Staff Report to the
Southeast Town Design Review Committee
December 8, 2016

MPL2016-00050
ITEM #2

7-ELEVEN DOWDEN ROAD

PROPOSED SITE PLAN

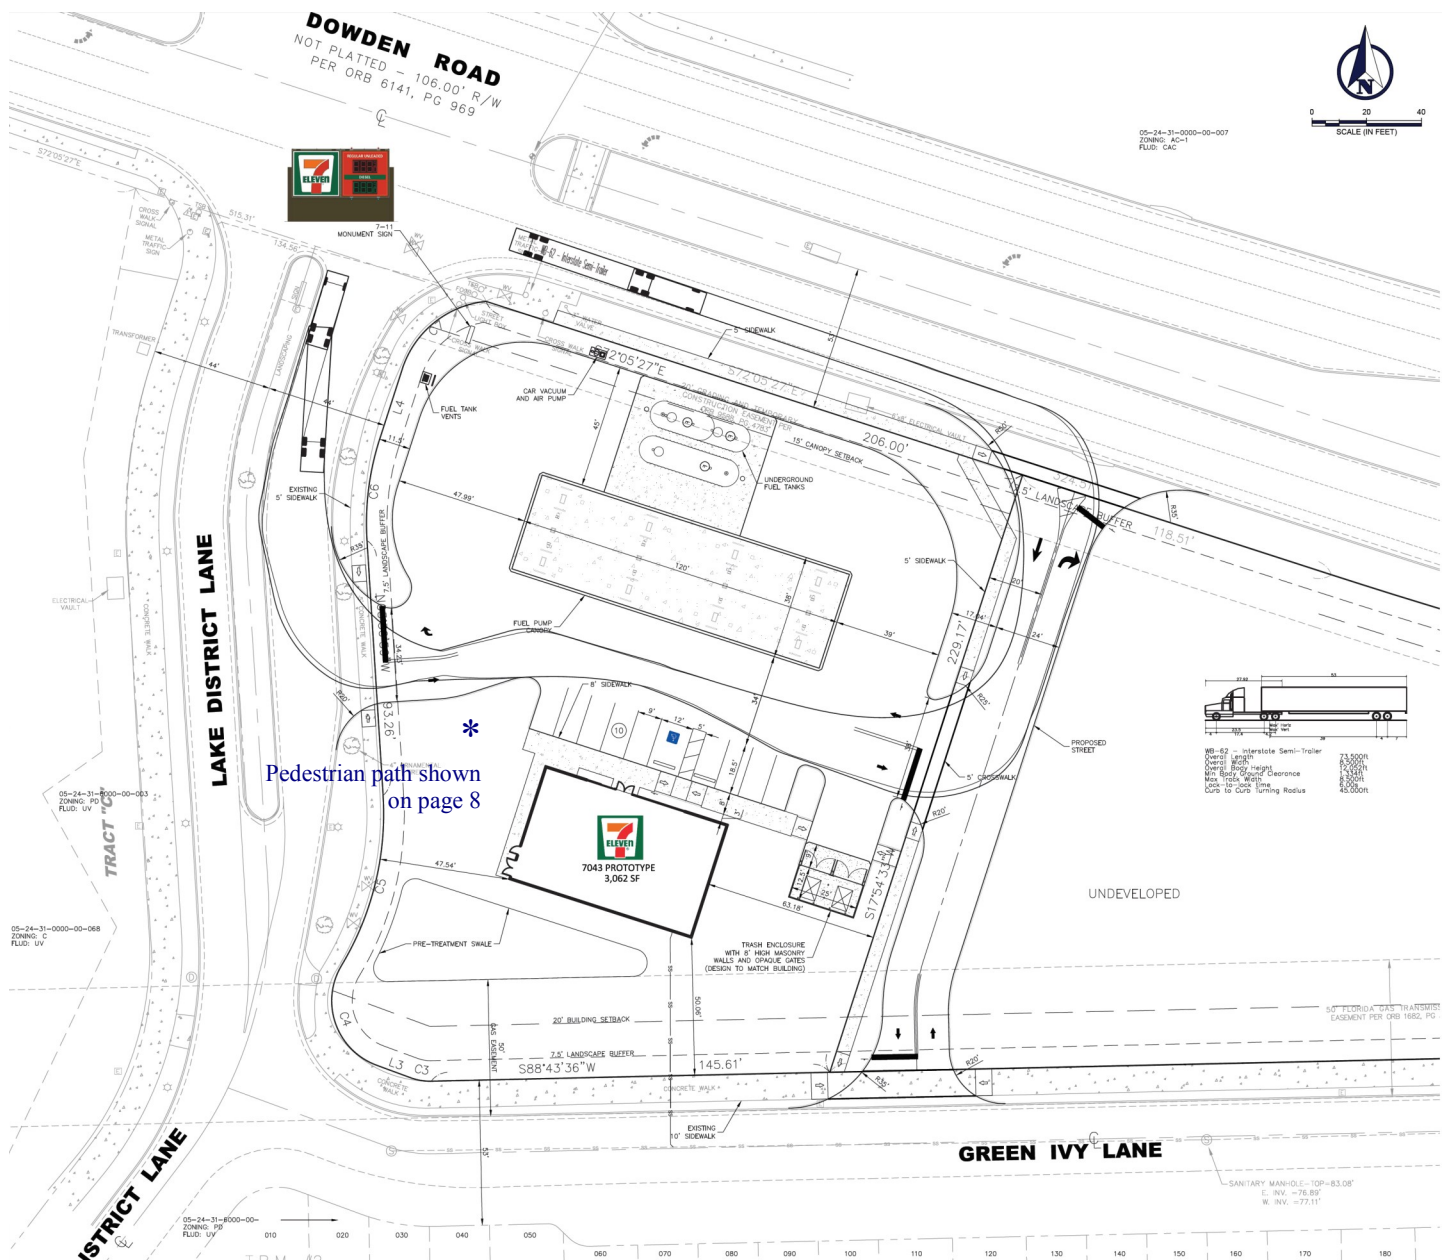
A 5 ft. wide concrete sidewalk parallels the north, east, and west property line and a 10 ft. wide multi-use concrete path follows the south property line, providing adequate pedestrian circulation alongside the perimeter of the subject site. The conditions of this report require and additional pedestrian connection from the sidewalk along Lake District Lane to the convenience store building. This connection shall be a minimum width of 5 ft. and ADA compliant.

Autoturn provided shows that the current truck route maneuvering would require mounting of the landscape island. Redesign driveway to allow for better maneuverability that would not affect the landscape island.

The ESM prohibits inlets within 3 feet of a driveway due to maintenance issues, the inlet that is within the driveway on Dowden Rd will have to be relocated (see ESM Section 8.11 Driveways and Entrances, E 1D pg 115) unless waived by City Engineer.

A pedestrian connection from the sidewalk along Lake District Lane to the building is required—minimum width of 5 ft. and must be ADA compliant.

LANDSCAPE PLAN

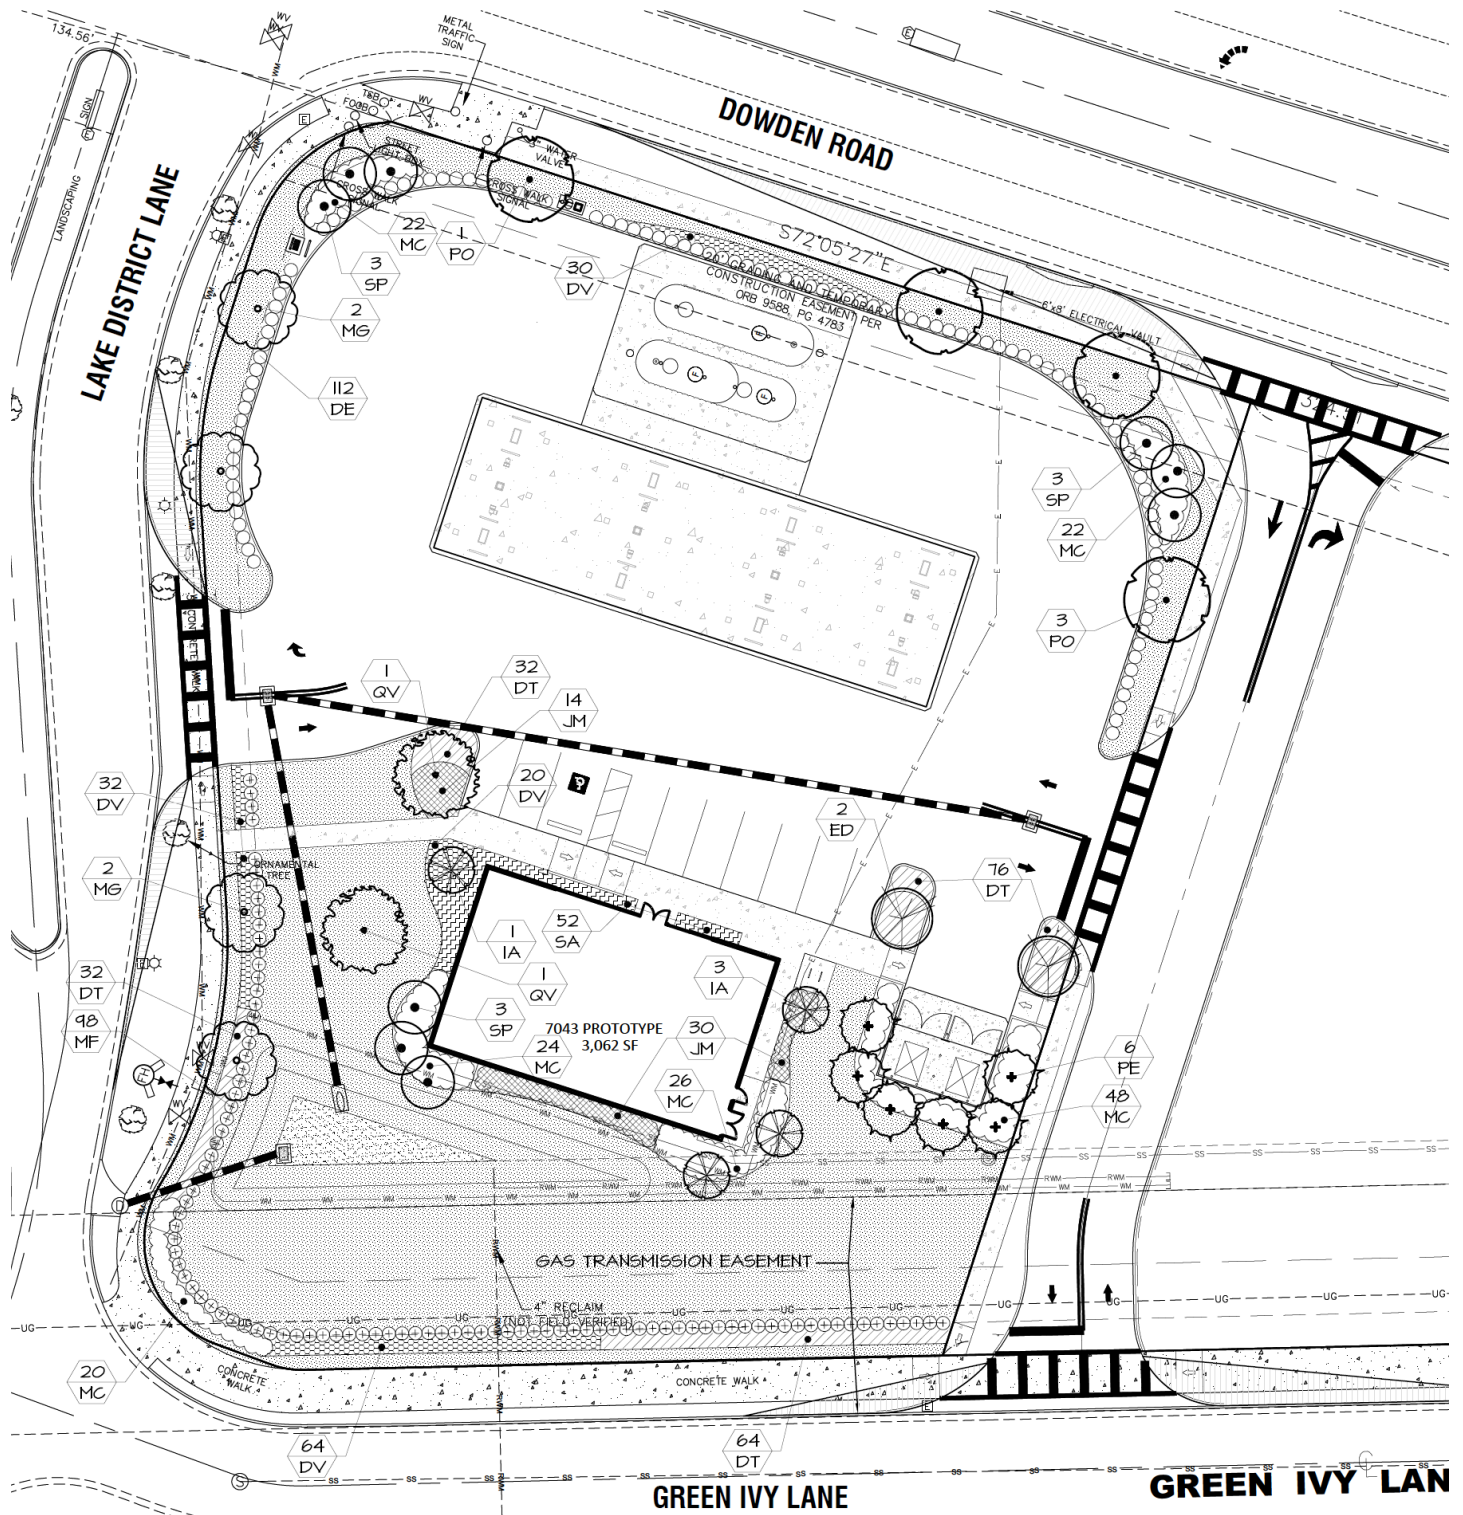
The proposed landscaping plan shows a 7.5 ft. minimum landscaping depth around the perimeter of the entire site and a minimum 4.5 ft. landscaping depth around the perimeter of the convenience store building. Staff has requested that any trees located within the gas easement area be relocated outside of the gas easement area. The dumpster location includes landscaping screening as well.

All proposed trees shown to be located in the gas easement area shall be relocated to outside of the gas easement area for the final landscaping plan.

SIGNAGE LOCATIONS

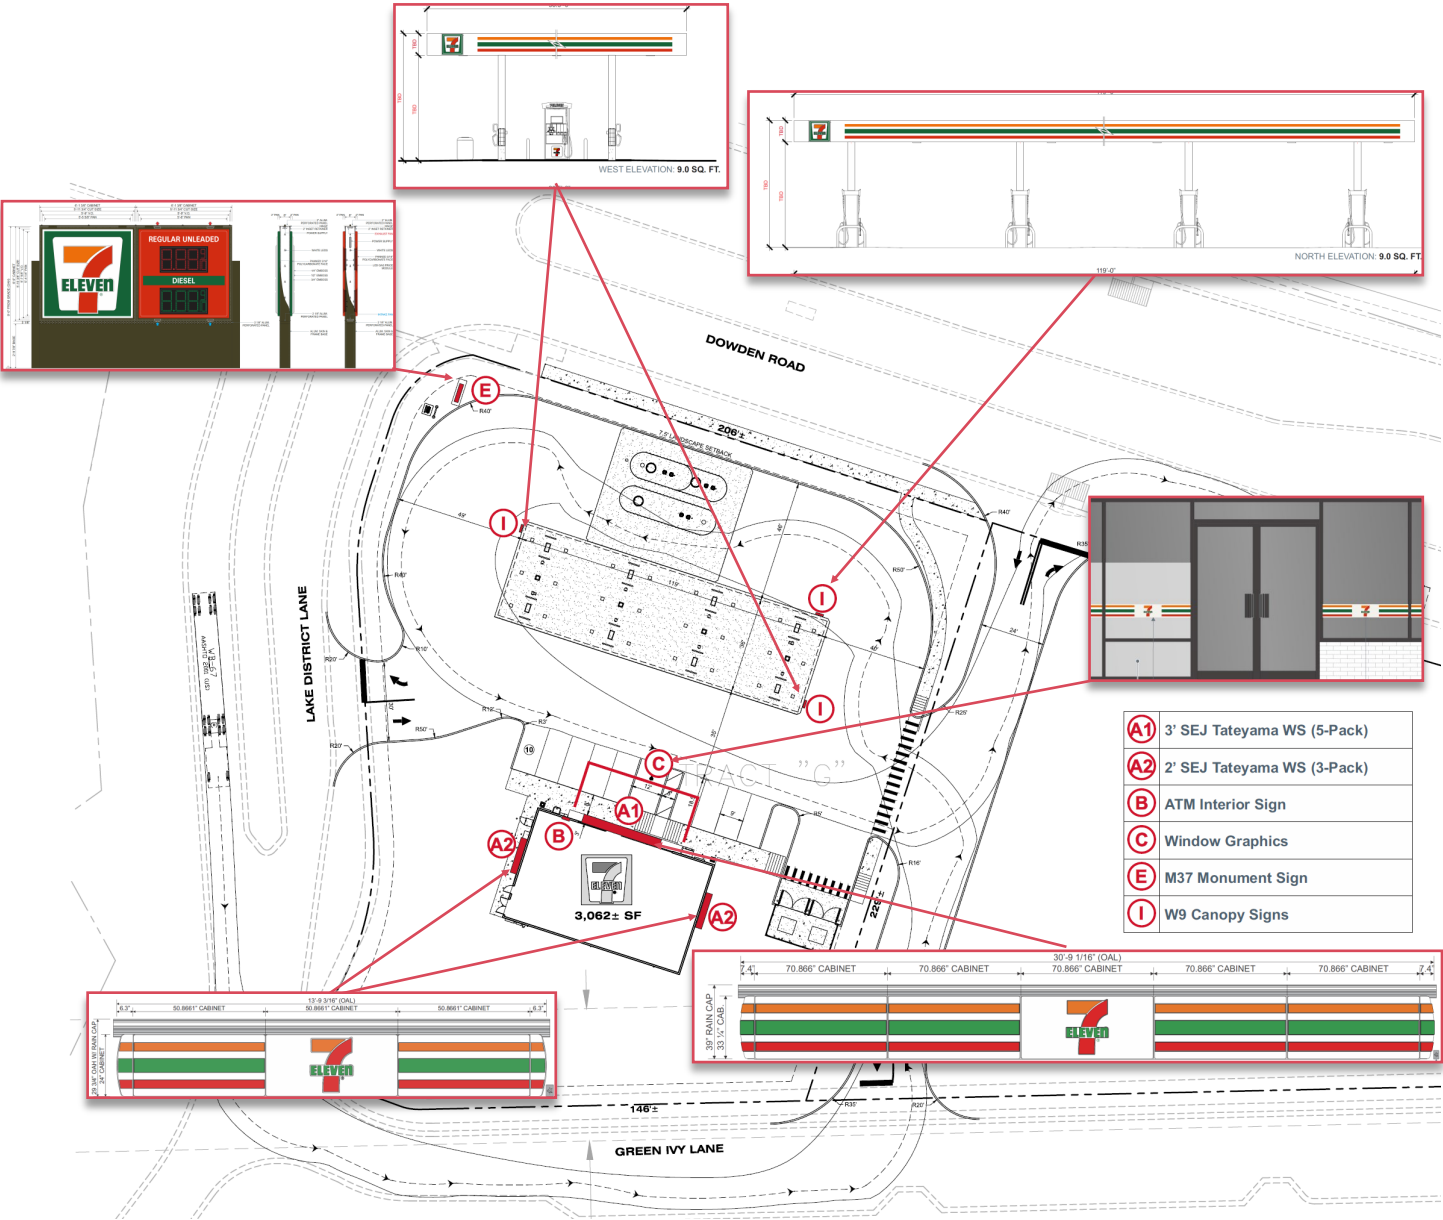
Chapter 64 permits 2 sq. ft. of signage copy area for every 1 lineal ft. of primary building frontage and 1 sq. ft. for every 1 ft. of secondary building frontage. Total primary frontage along Dowden Rd equals 70 ft. and secondary frontage along Lake District Ln equals 43 ft. resulting in a total allowable copy area of 183 sq. ft. A sign package submitted for review shows 9 sign locations (see page) with a total proposed copy area of 240.7 sq. ft. The conditions of this report require that signage not exceed 183 sq. ft.

Signage copy area shall not exceed 183 sq. ft. per LDC Chapter 64.
